TECHNICAL BULLETIN

**Creak Under Light Braking –
Front Brake Caliper Pad Interface –
Grease Anchor Bracket**

MODEL 2006 MY-ON
XJ range
VIN G49701-ON

ILLUSTRATION 1

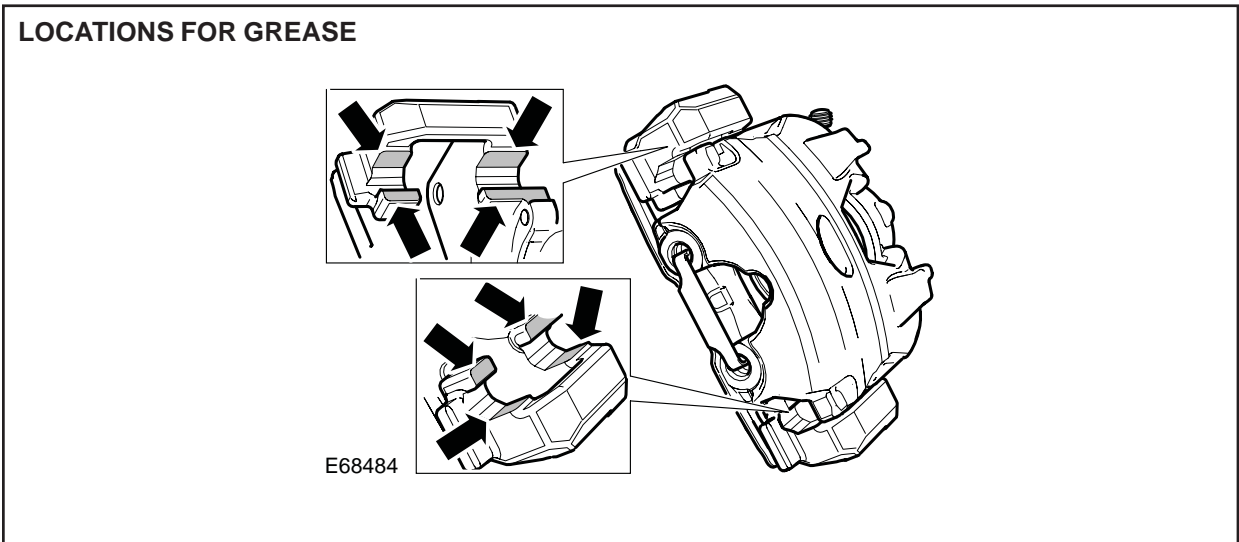
This bulletin addresses customer concerns of a creak noise emanating from the front brakes with light brake application, at slow speed, and maneuvering the steering. The noise can also be heard when coming to a stop in the straight-ahead position with light or medium braking.

Cause: Front brake caliper to brake pad anchor bracket interface.

1. Remove front brake pads (see Global Technical Reference GTR Workshop Manual, section: 206-03).
2. Clean and apply grease to the locations shown in Illustration 1, on the anchor bracket for the front brake caliper.
